RESPONSES TO QUESTIONS BY NSW COASTAL PANEL

RE: REPAIRS TO SEAWALL AT 28 & 28A CHILDE ST, BELONGIL
REF: DOC17/82318

REPAIRS TO SEAWALL AT 28 & 28A CHILDE ST, BELONGIL

Figure 1 Schedule 1 from Court Orders with site, Manfred St and Belongil & wetland locations added.

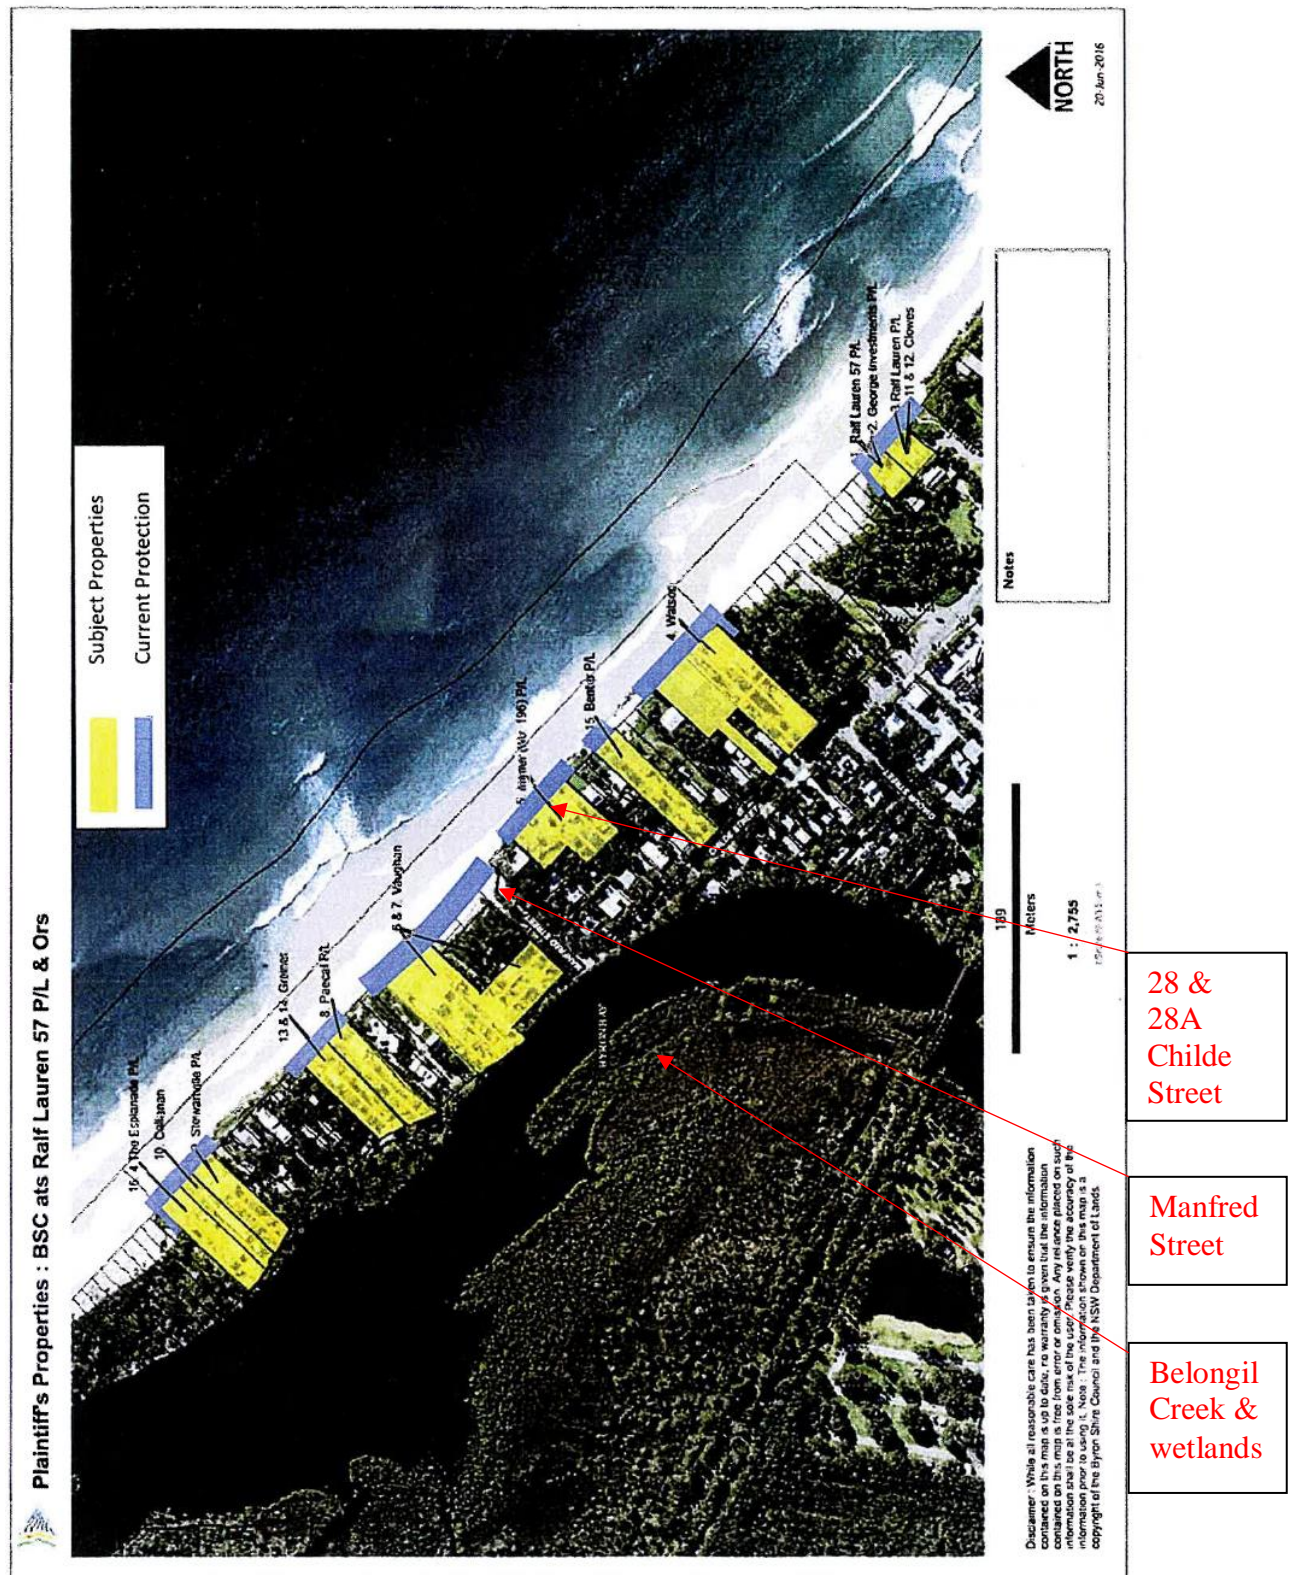
- b. **Sufficiently accurate cross sections of the proposed structure (including its proposed points of termination and/or method or tie if there are existing approved works on either side) and its location relative to the existing property boundaries (including the crown road reserve). Such cross sections to clearly specify all relevant dimensions (including crest, toe and existing beach levels)**

The Supreme Court of NSW consent orders show the extent of the wall for the subject property to be repaired as extending in front of the adjacent properties (Figure 1). This overlap was provided to allow a smooth transition of the repaired walls into the adjacent walls to avoid a weak area at the boundaries or adverse impacts on the adjacent walls during or after repairs.

X-SECTION A (PRESENT)

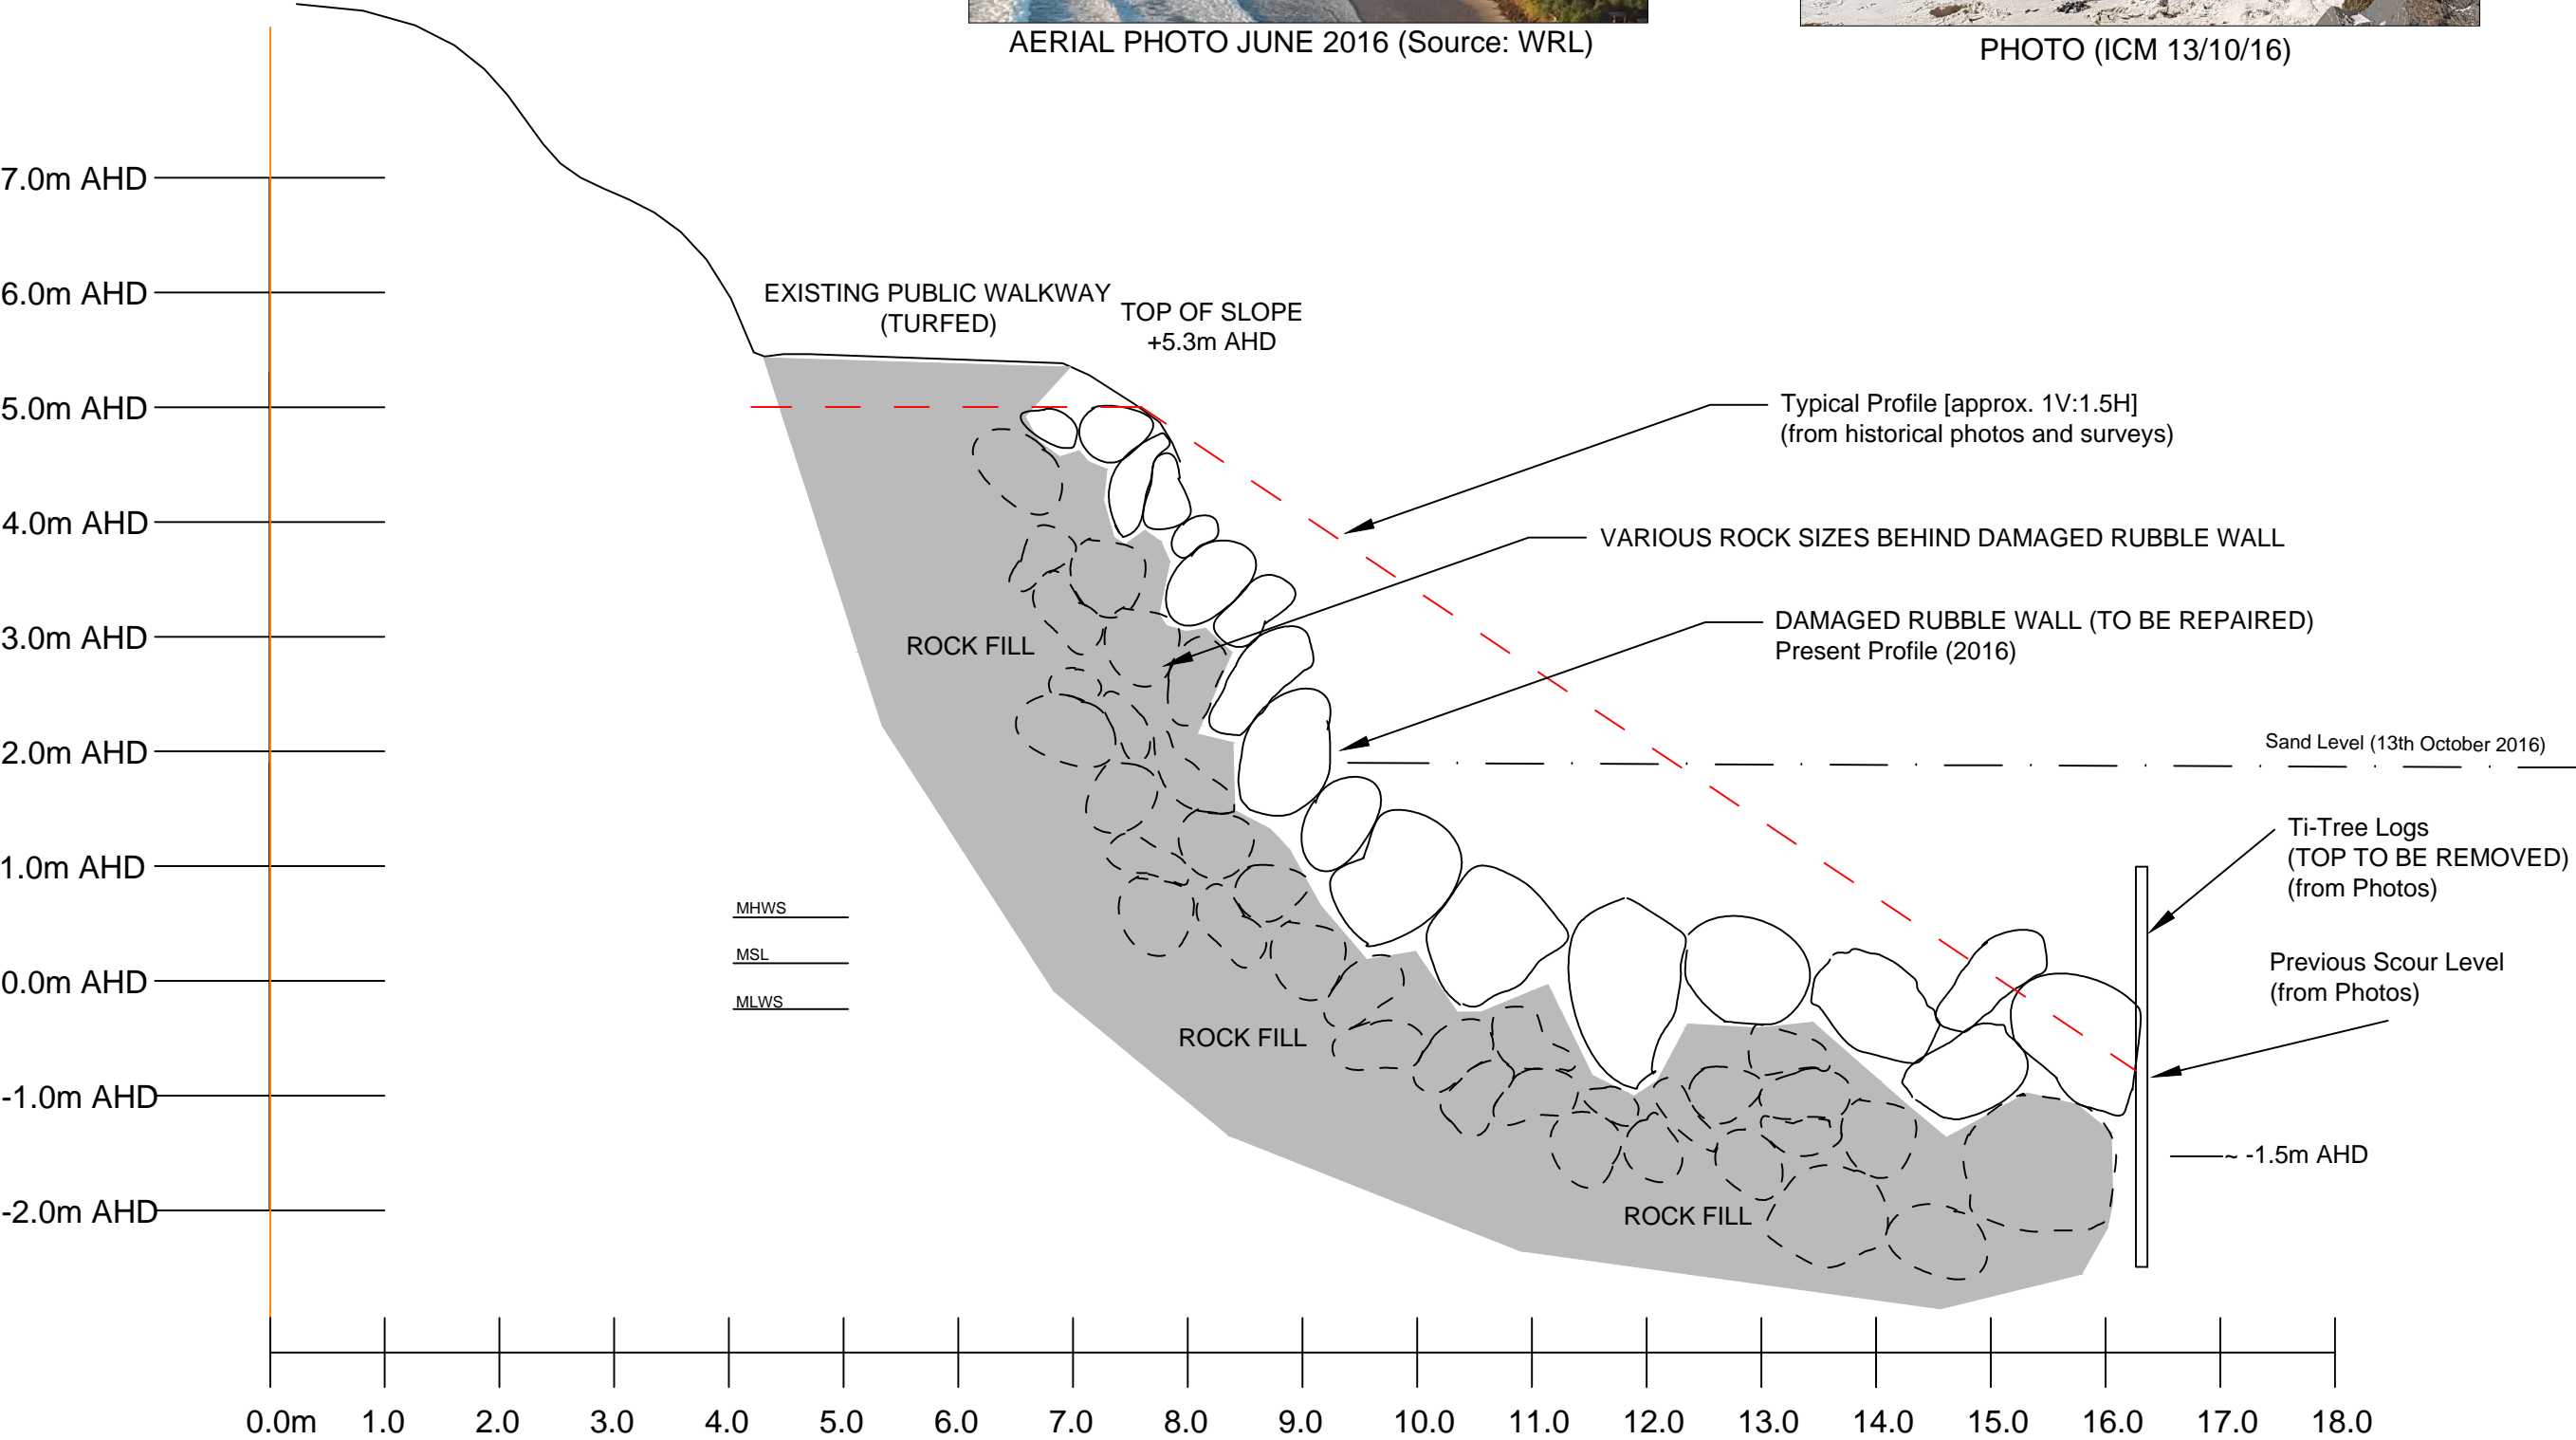
g. Toe scour levels;

Response: The existing wall have largely accommodated toe scour over its life. The typical scour levels are shown in the x-sections in drawings 003 and 005 (Attachment A).

TYPICAL REPAIR PROFILE A

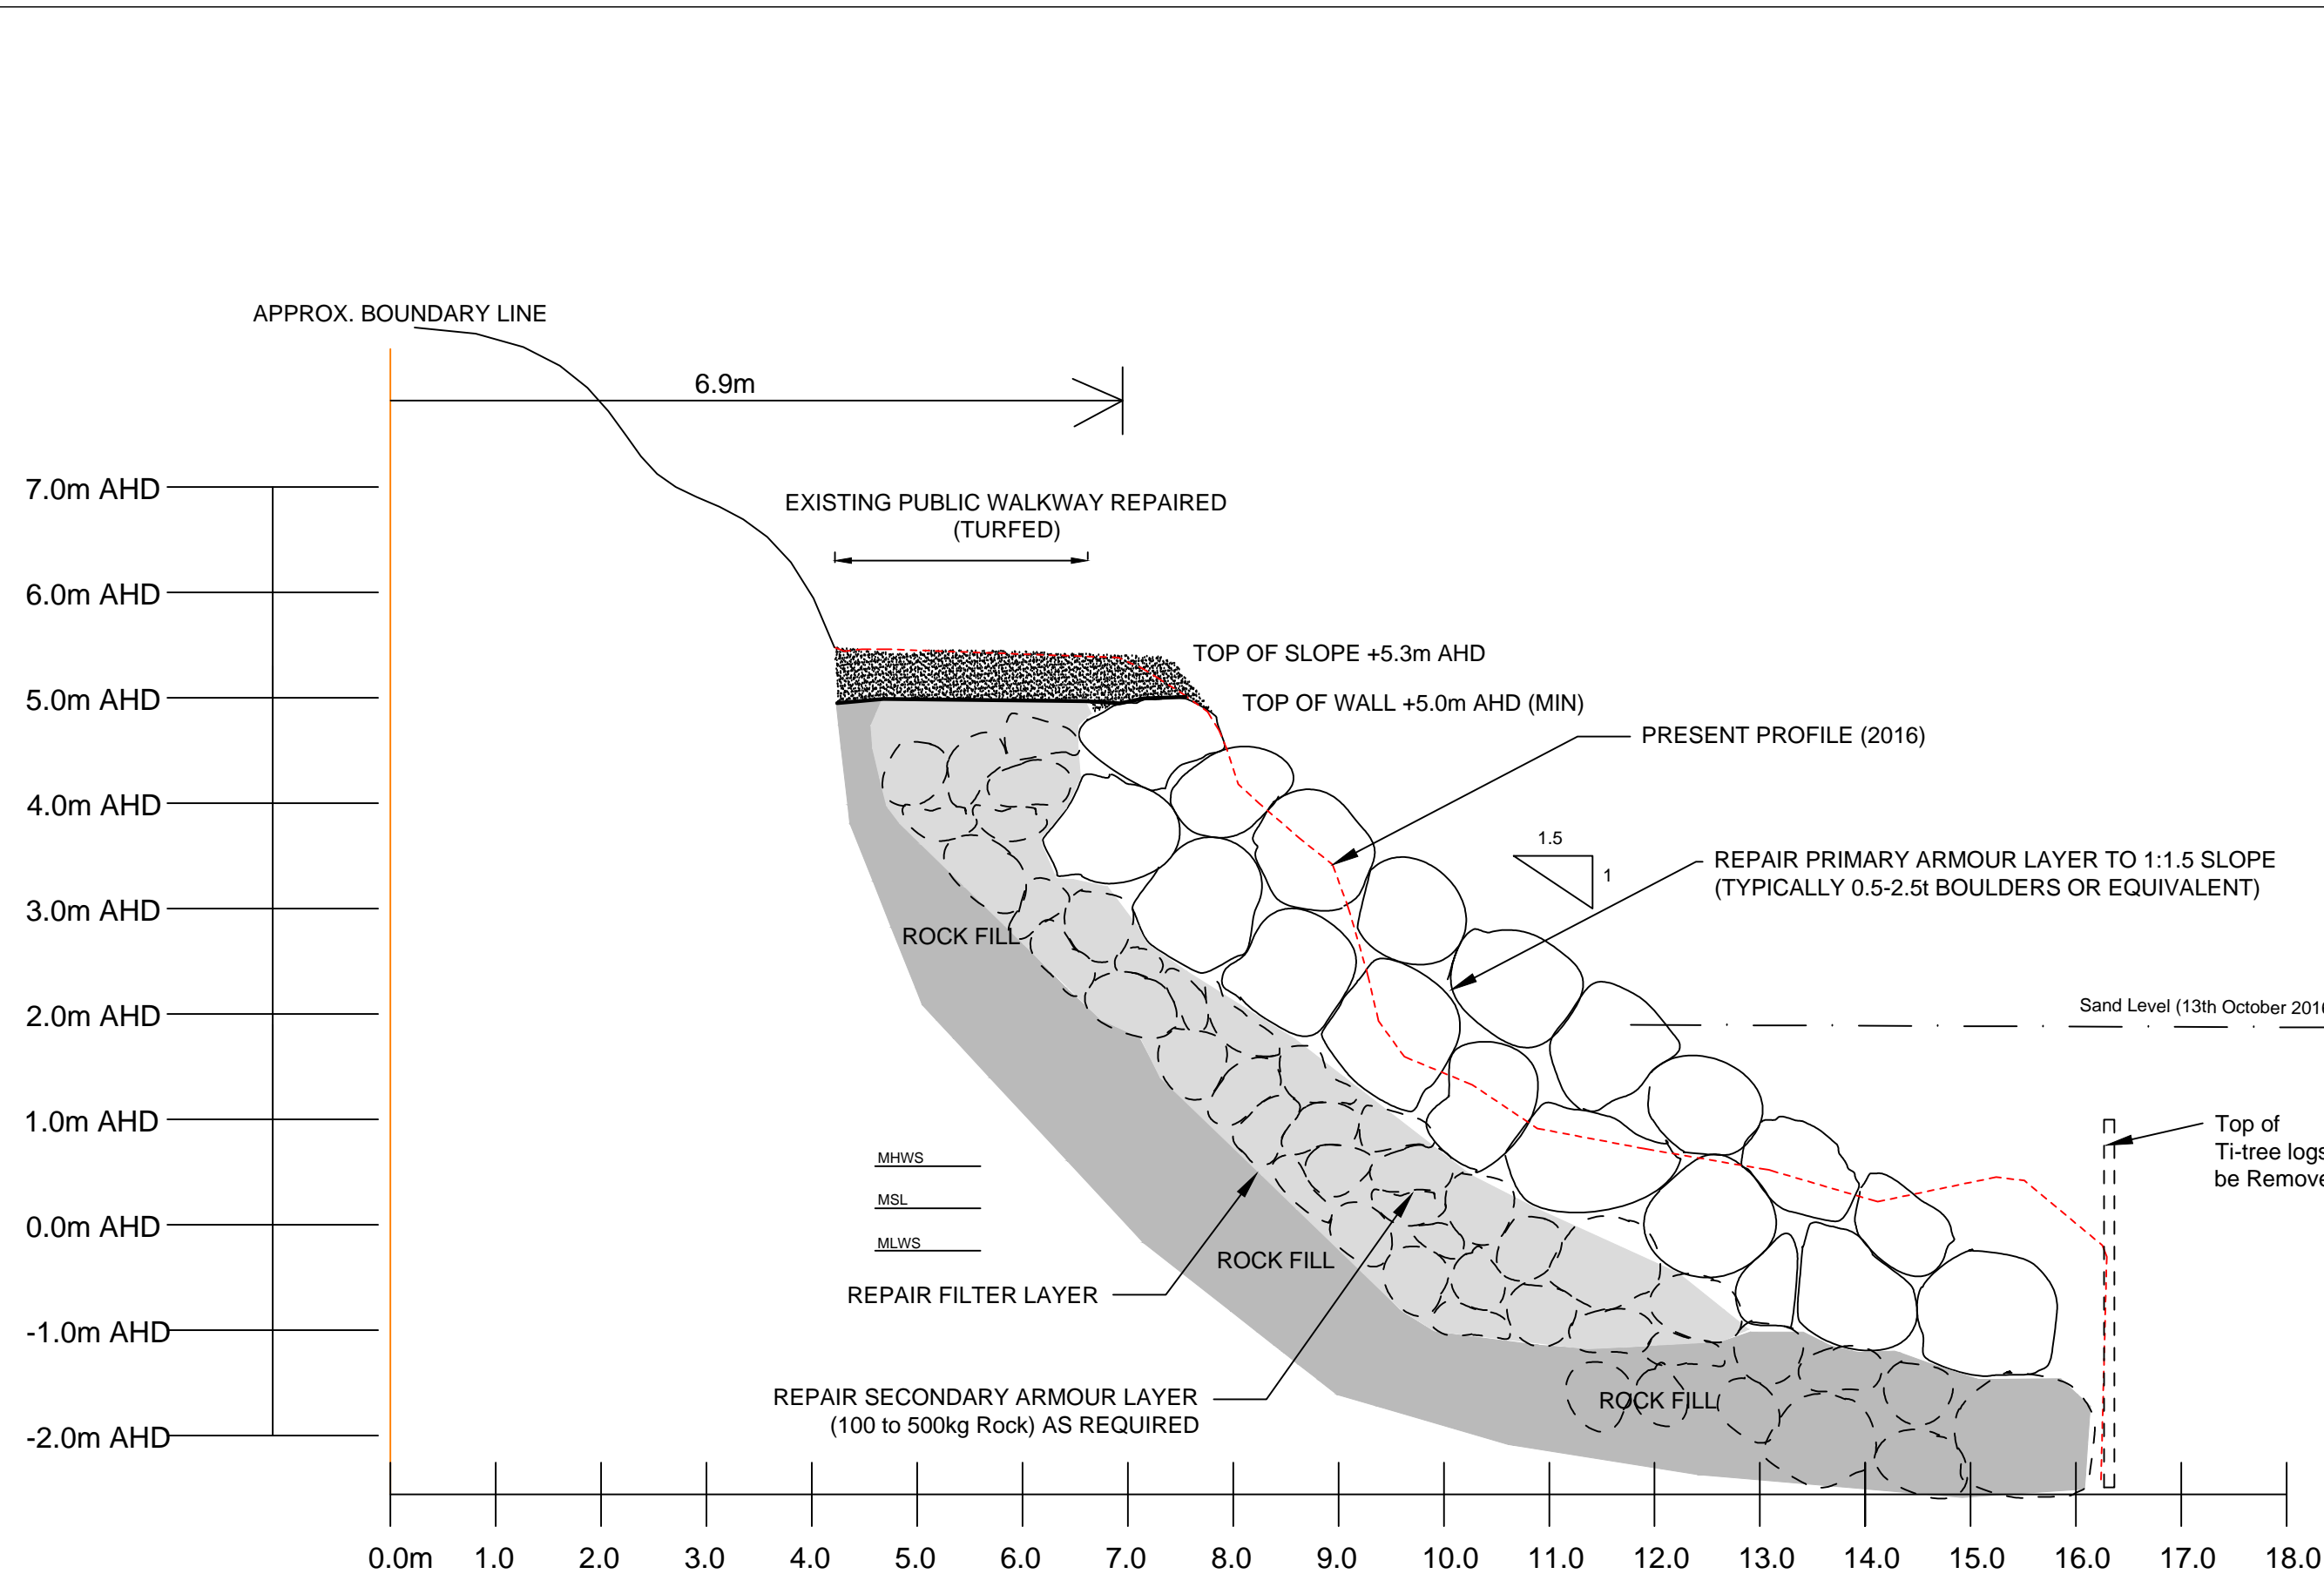
h. Crest levels;

Response: The existing crest levels have been adequate and the repaired crest levels are shown in the x-sections in drawings (Attachment A).
